AGENDA
CITY OF LAKE WORTH BEACH
HISTORIC RESOURCES PRESERVATION BOARD REGULAR MEETING
CITY HALL COMMISSION CHAMBER
WEDNESDAY, JUNE 09, 2021 -- 6:00 PM

MEMORANDUM DATE: June 2, 2021

TITLE: **HRPB Project Number 21-00100156:** Consideration of a Certificate of Appropriateness (COA) for garage door installation for the property located at **501 South Palmway**; PCN #38-43-44-27-01-003-0100. The subject property is a contributing resource to the South Palm Park Local Historic District and is located within the Single-Family Residential (SF-R) zoning district.

Proposed

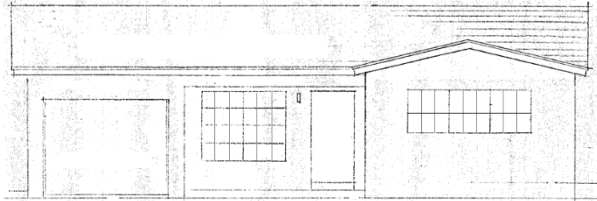
The current request is for an XO horizontal roller for the window on the left, and an XOX (quarter – half – quarter configuration) horizontal roller for the window on the right. The proposed configurations are full-view, and do not attempt to replicate the windows being removed, or a compatible alternative for the structure’s architectural style.
